Design Process Tie To Southwest Context and Simplify Facade

SECTION 3

DESIGN PROPOSAL

Revised Facade

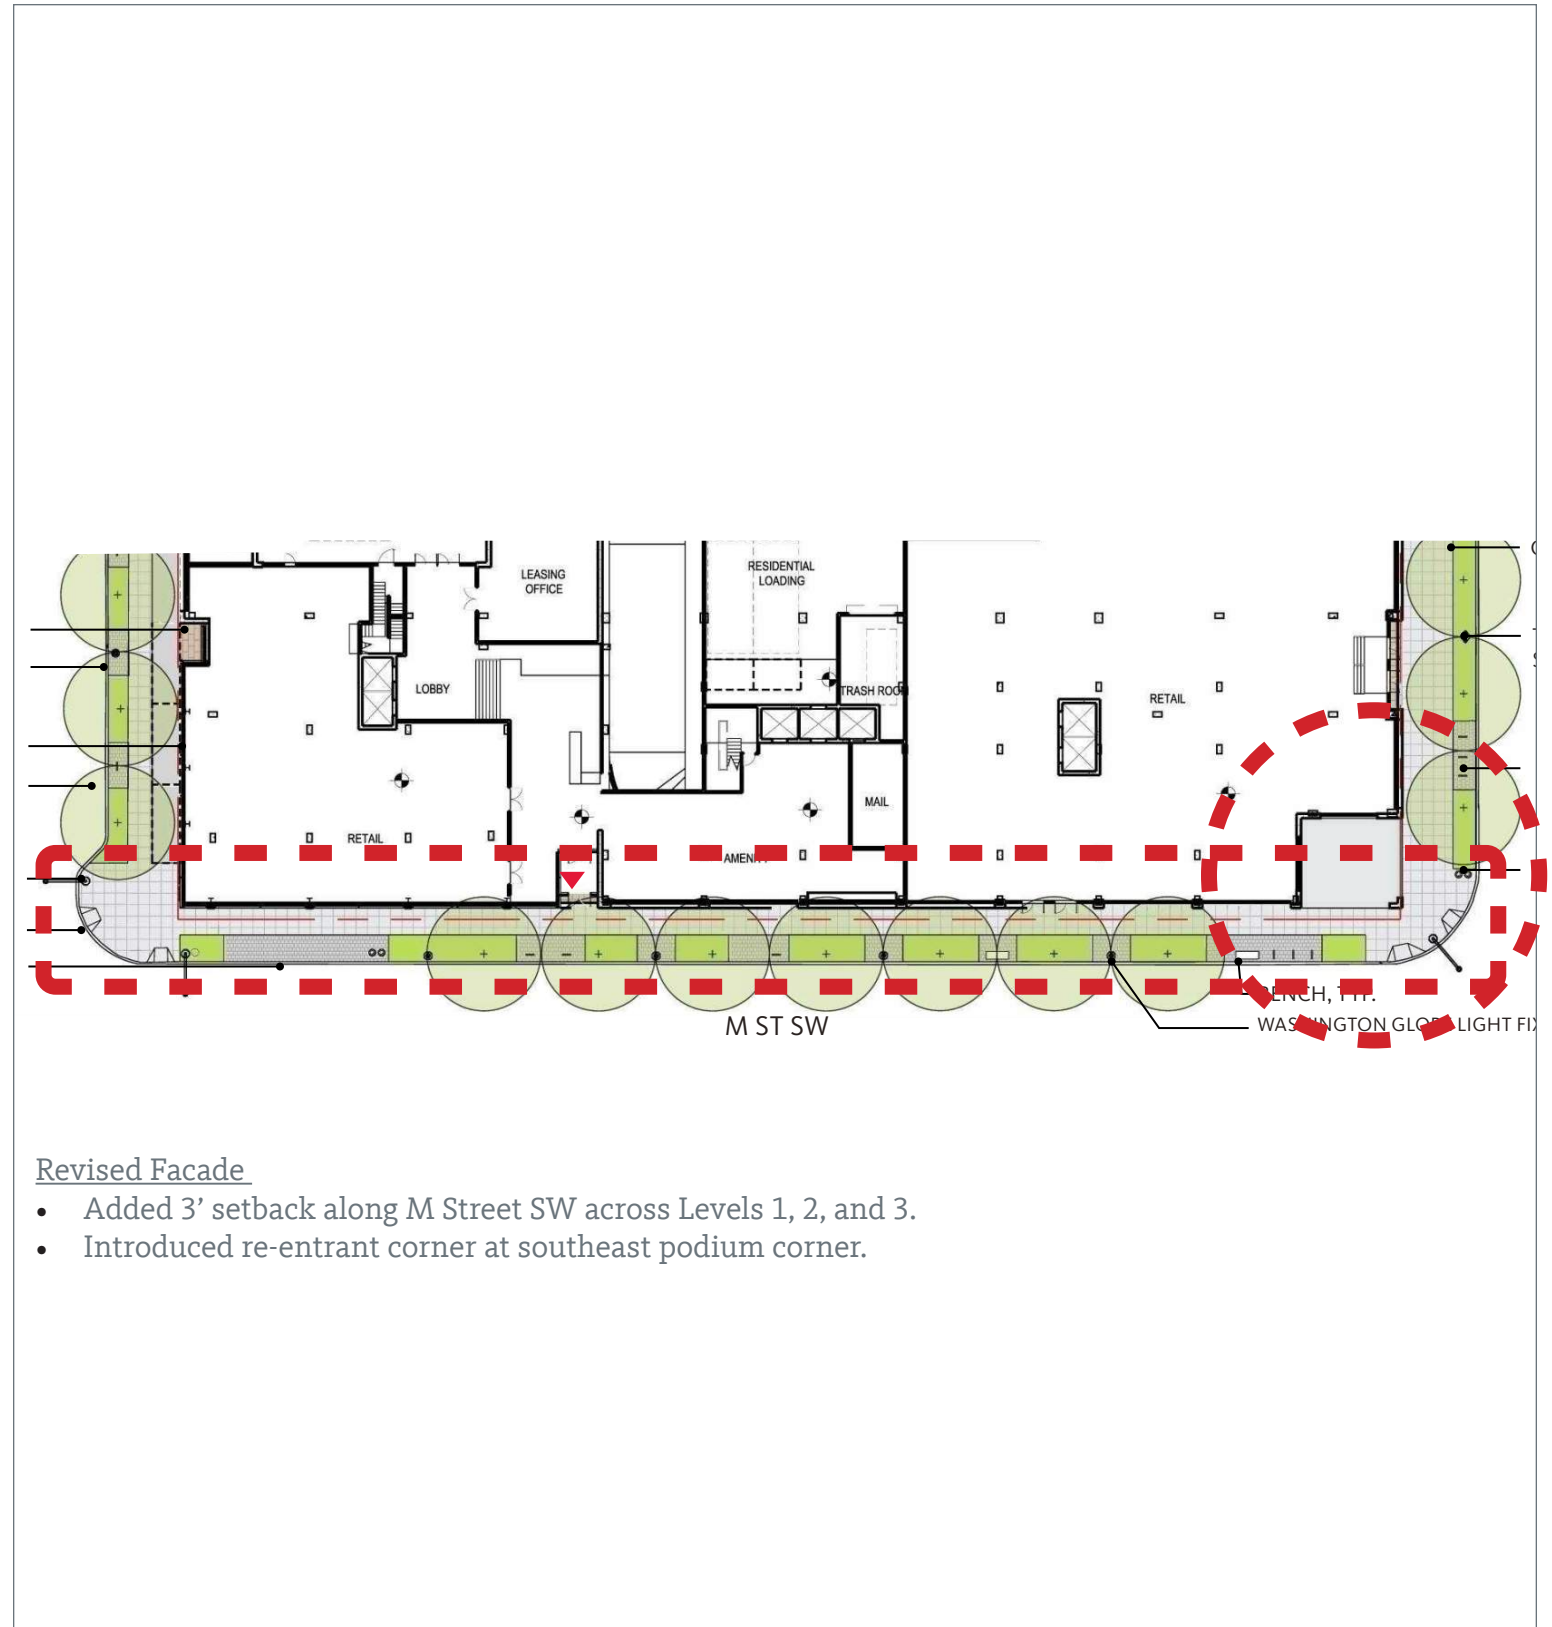
- Added 3' setback along M Street SW across Levels 1, 2, and 3.
- Introduced re-entrant corner at southeast podium corner.

Revised Facade

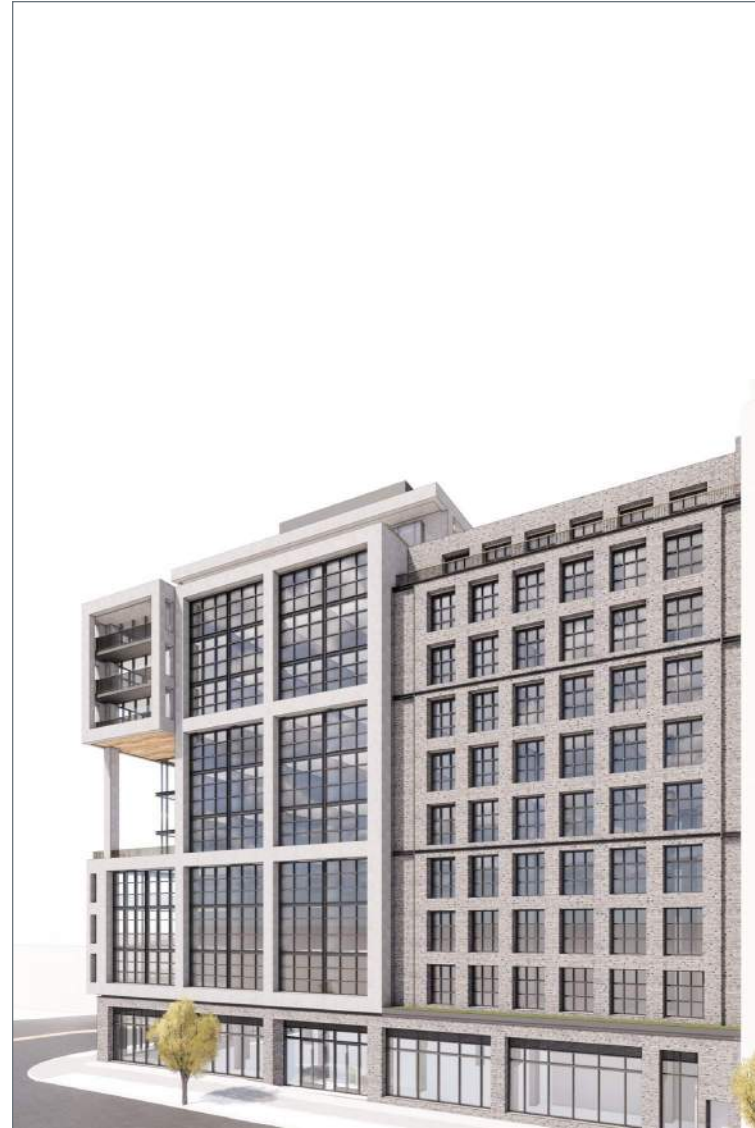
- Added setback at levels 12 & 13 that aligns with upper pavilion setback (10'-0").

- Created continuous inset balcony at 10th and 11th floor to inwardly step the massing.

- Removed all rotated ('hopper') balconies AND windows.
- Extended inset balcony design from SE corner across facades.
- Increased quantity of balconies.
- Replaced picket guardrails with glass guardrails
- Converted brick back to concrete.

Revised Roof Level

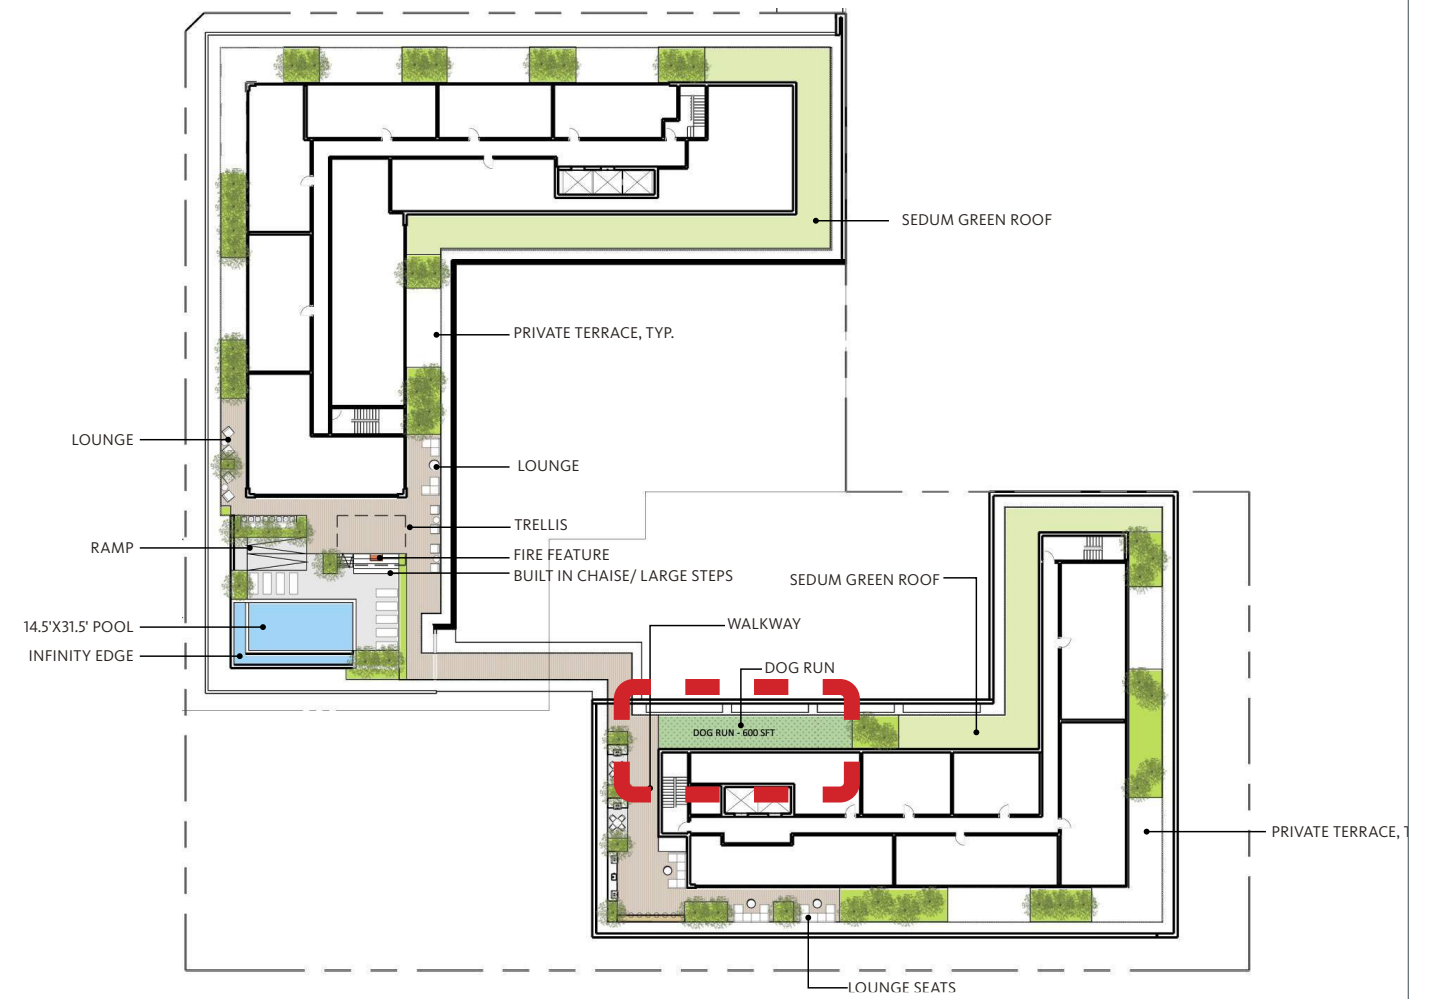
- Added dog relief zone.
